**Pacific Gas & Electric Company**  
**ELC (Corp ID 39)**  
**Status of Advice Letter 6287E**  
**As of August 30, 2021**

Subject: Modifications to Electric Rule 21 Pursuant to Decision 20-09-035 Addressing Remaining Ordering Paragraph Issues in Working Group 2 and 3

**Advice 6287-E**

**Subject: Modifications to Electric Rule 21 Pursuant to Decision 20-09-035 Addressing Remaining Ordering Paragraph Issues in Working Group 2 and 3**

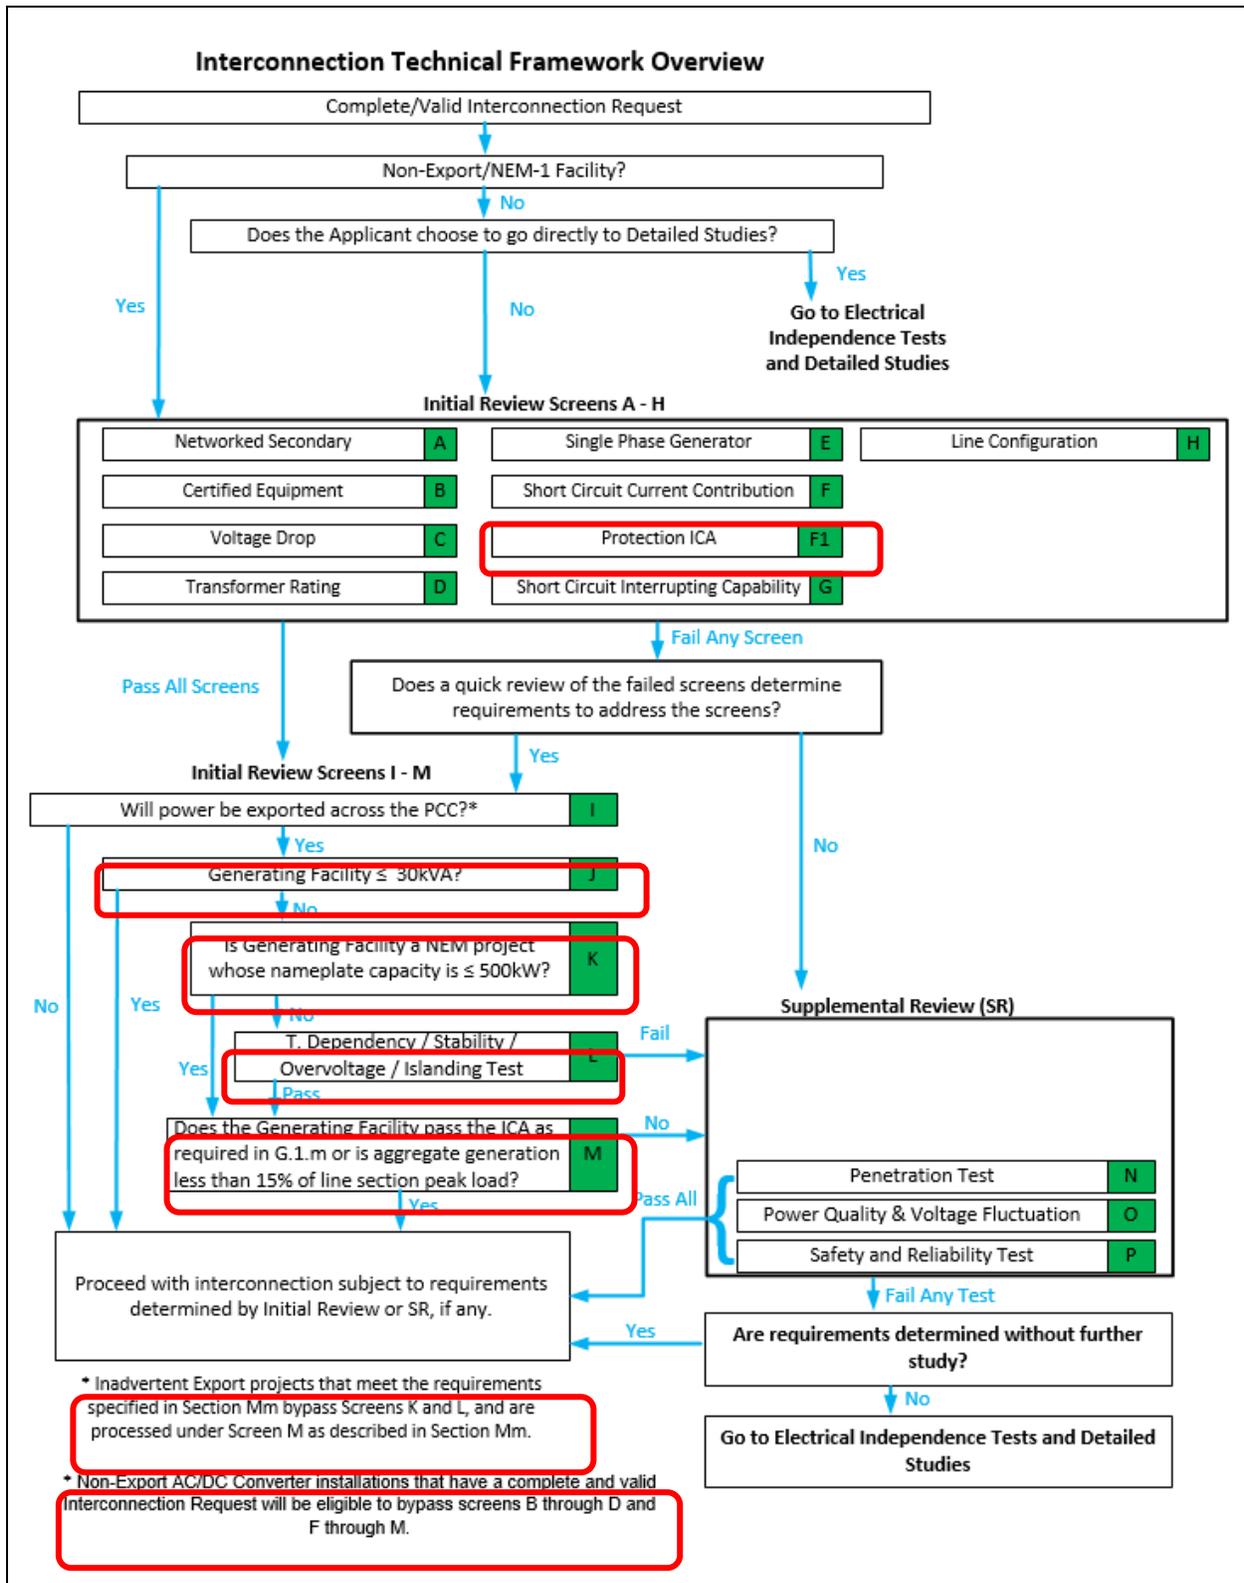
PG&E updates the Engineering Review Details flow chart (original sheet 145) consistent with the OP changes above. Additions circled in Red.
